Village of Cottage Grove
Meeting

PLAN COMMISSION

Wednesday, January 8, 2020
Hall

MSA has reviewed the Concept Plans submitted December 20, 2019 for the proposed Comfort Suites Hotel along Landmark Drive.

FARRIS AUTO CONCEPT PLAN - PHASE 1 (EARLY SPRING 2020)

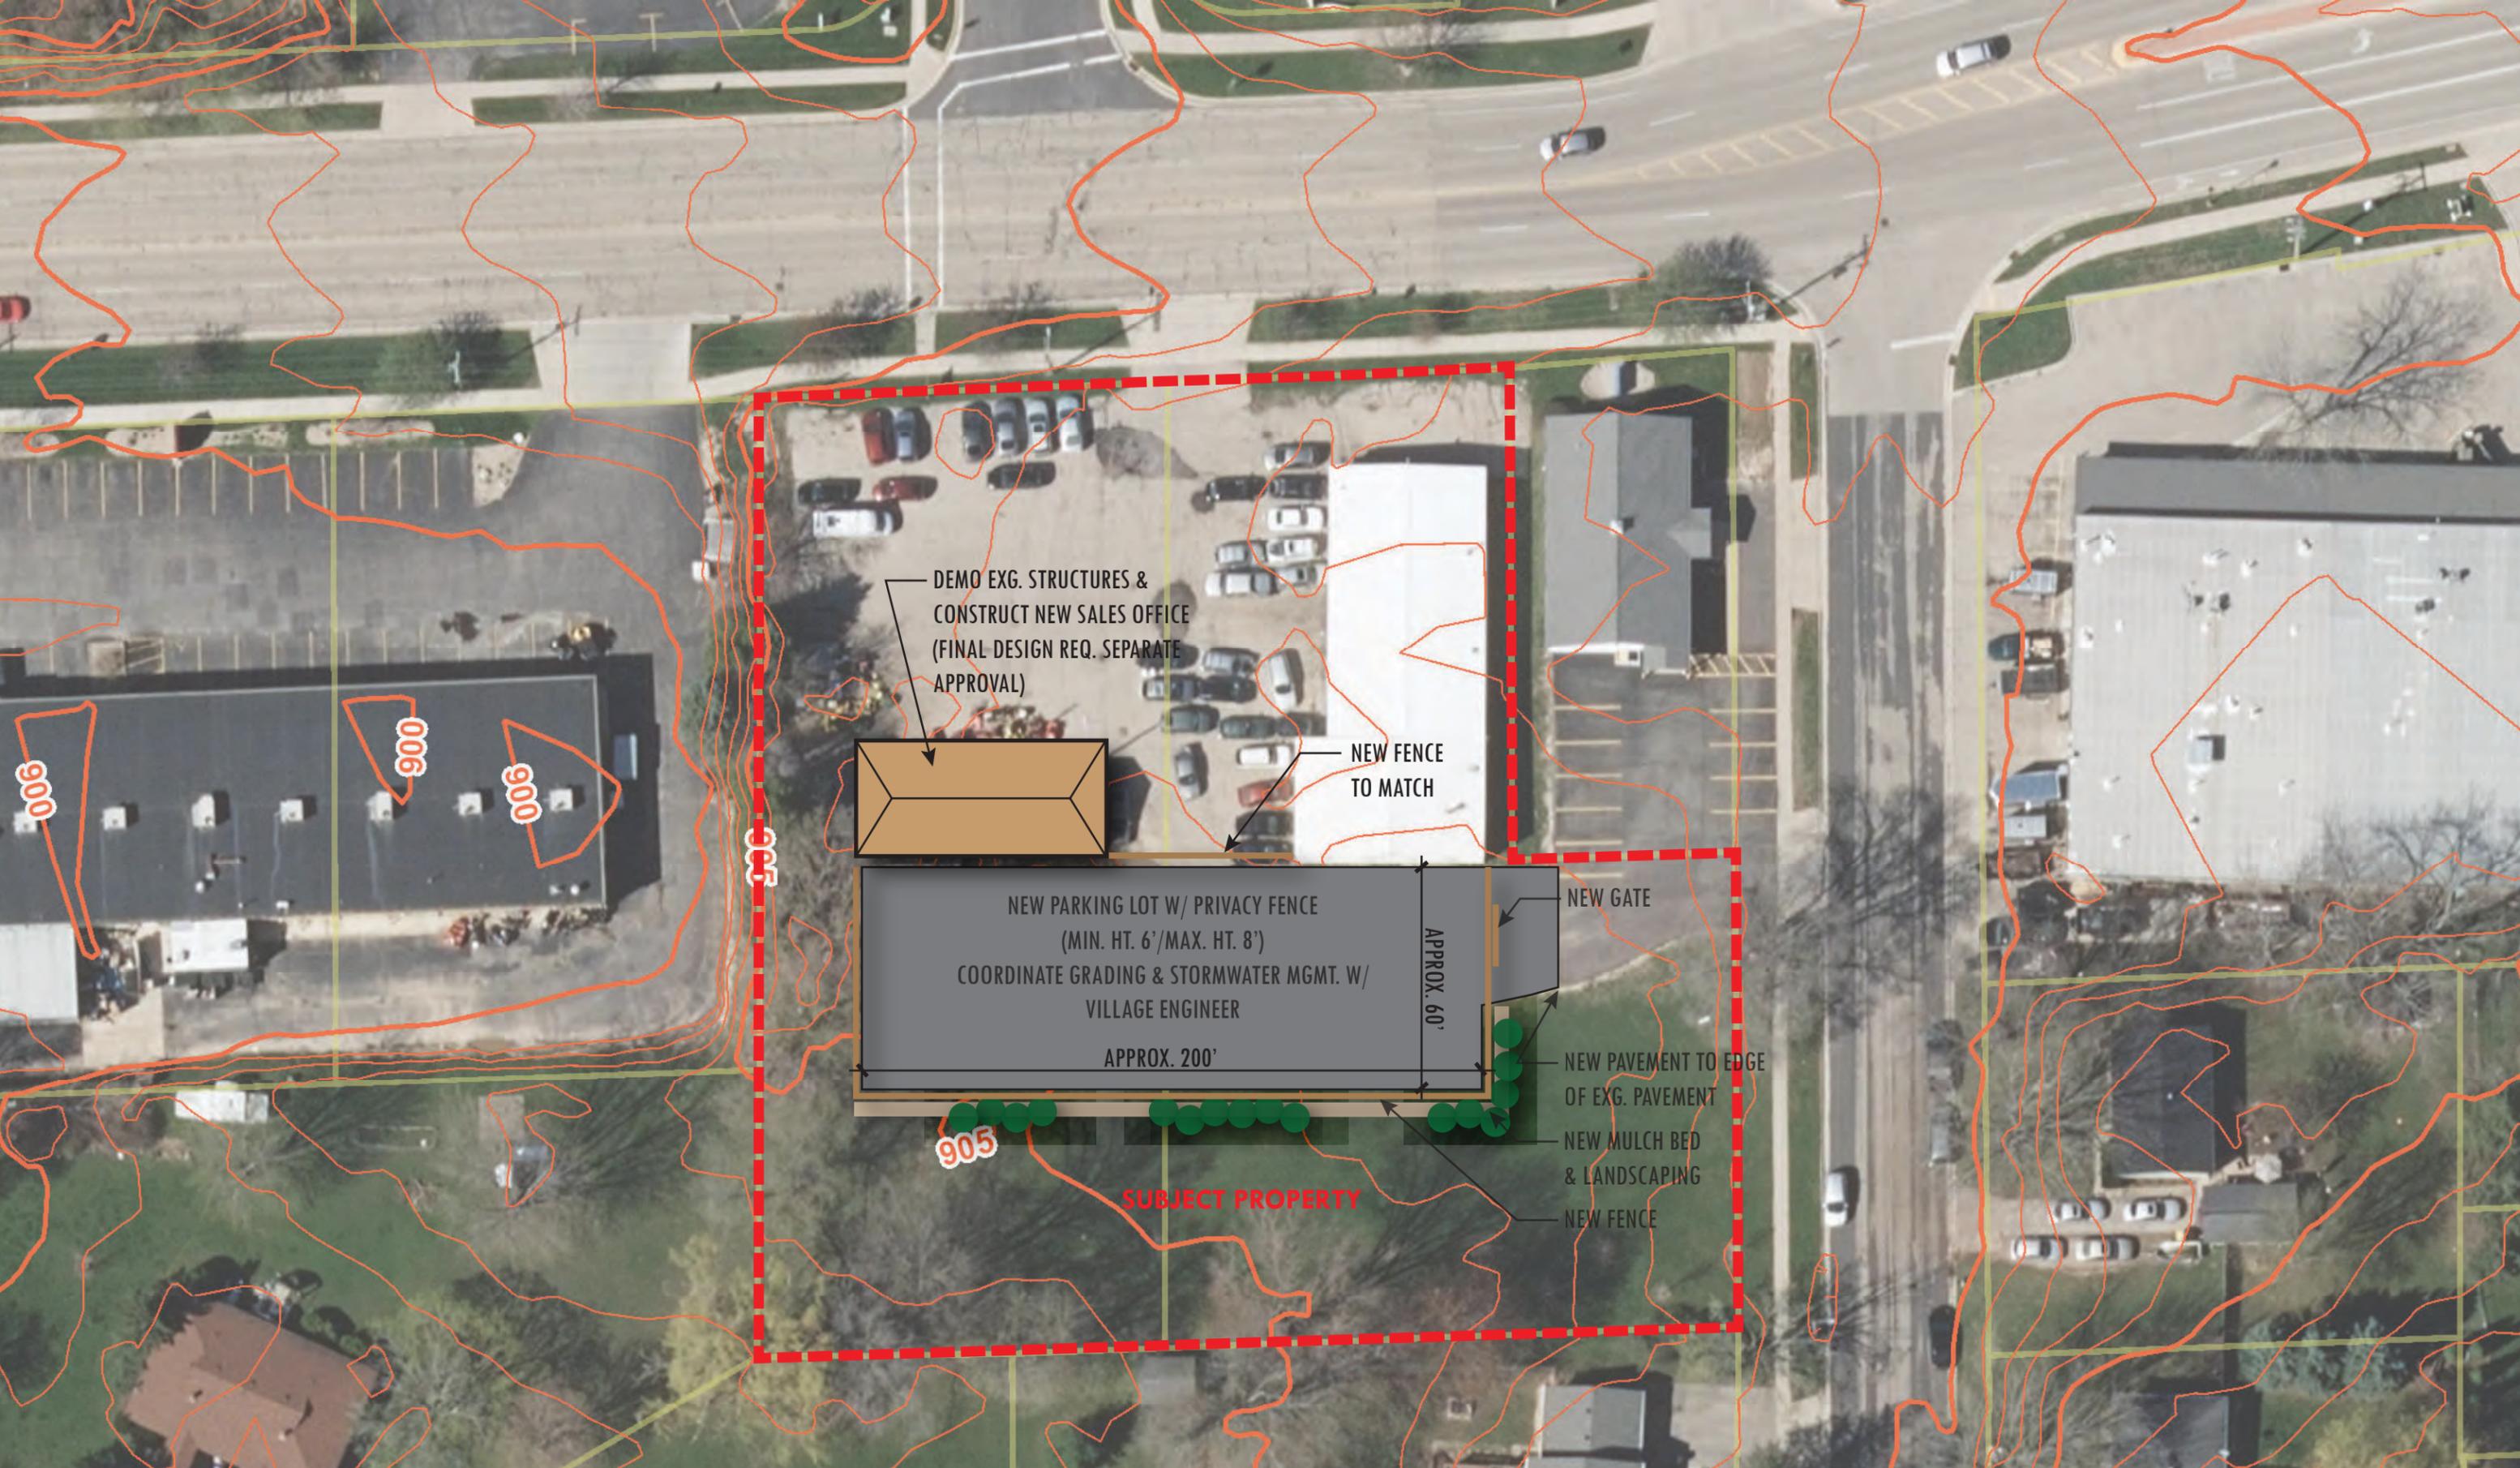
Staff recommends the amended Conditional Use Permit be **APPROVED WITH CONDITIONS**, with the conditions as follows:

6. Phase 1 shall include the elements shown in the attached Phase 1 plan including paving, fencing, and landscaping. Coordinate erosion control, stormwater management, and grading with the Village Engineer prior to issuance of a land disturbance permit.

General Development Plan

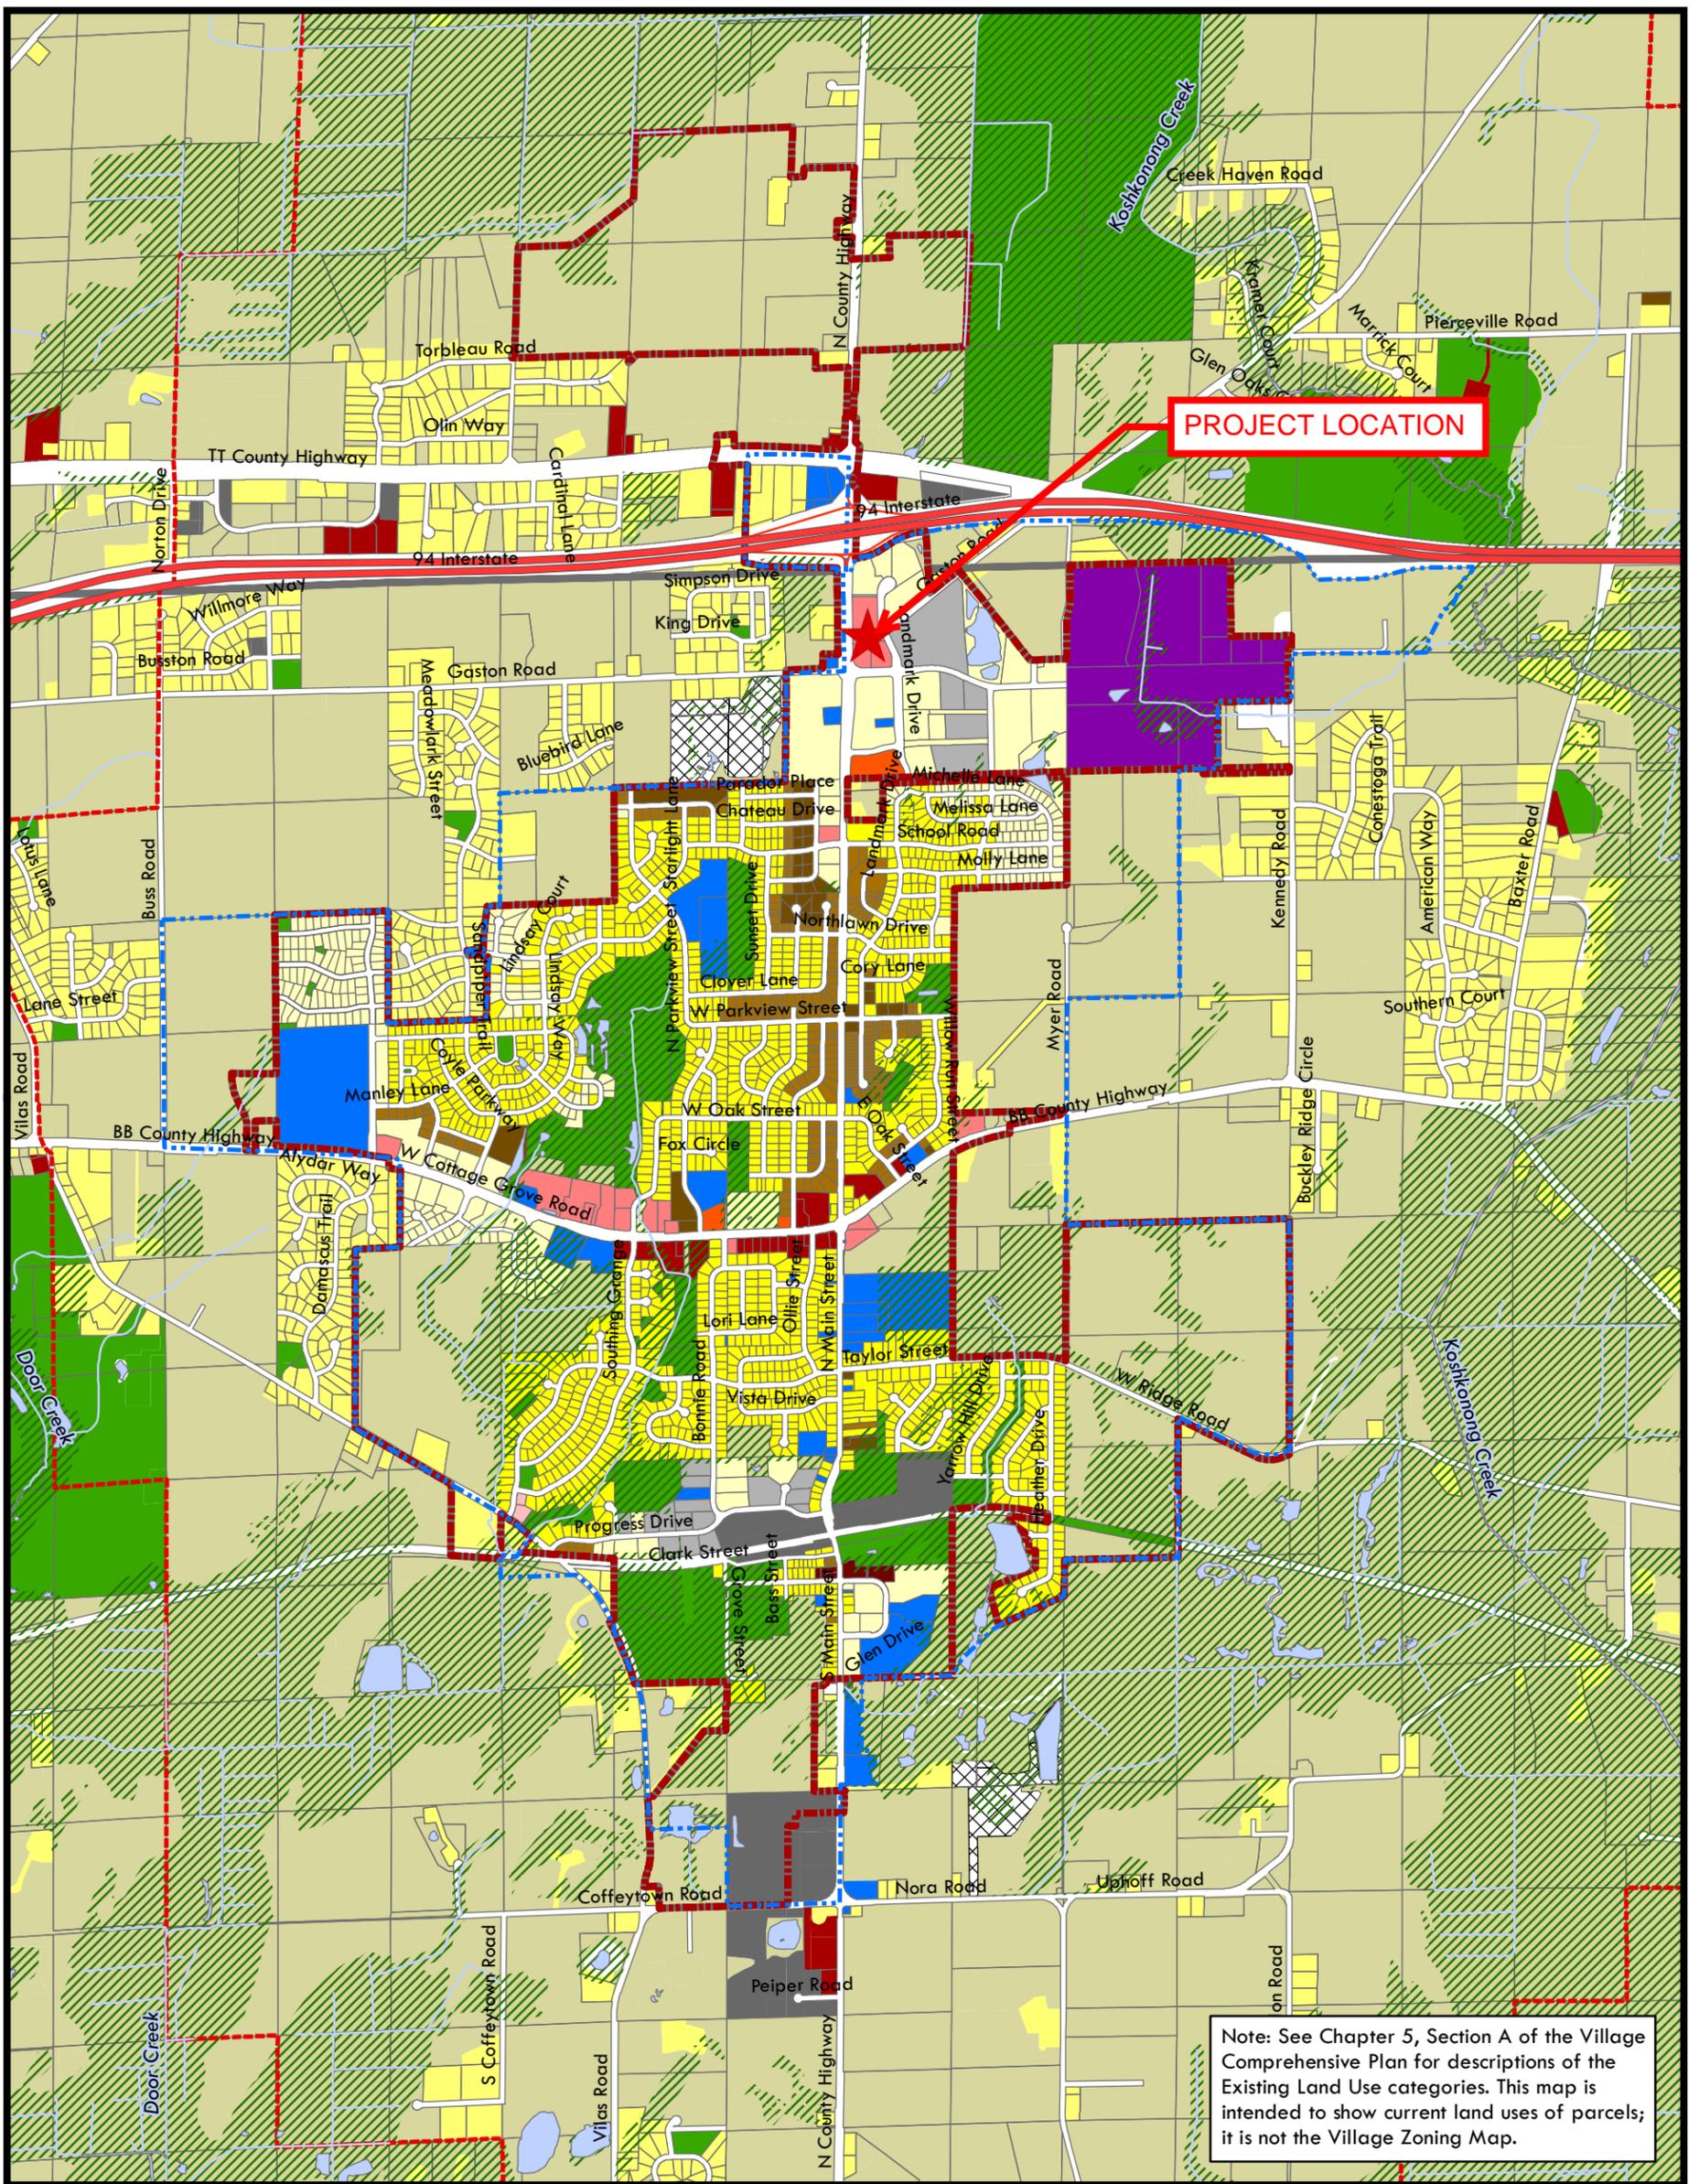
1. The sidewalk adjoining parking lots where curb and gutter is not shown should be raised sidewalk.
2. Tree locations should be revised based on the location of the sanitary sewer line and cleanouts shown on the existing survey.

3. Verify that one-half the area of the trash enclosure is sufficient for the site in the case the properties become independently owned in the future.

4. The north side of the hotel should be reviewed. Concrete patio is planned and fenced on the property on the north side of the building which is on land owned by the other property and will limit the use of that land by the northerly property owner. A property line adjustment or permanent easement should be attained for the patio use to avoid concerns if properties are sold in the future.

5. The concrete patio's are overtop existing storm sewer and a sanitary clean out. Access structures and drains will need to be maintained. Existing brick columns for the Pergola Overhang exist within the proposed concrete patio area.
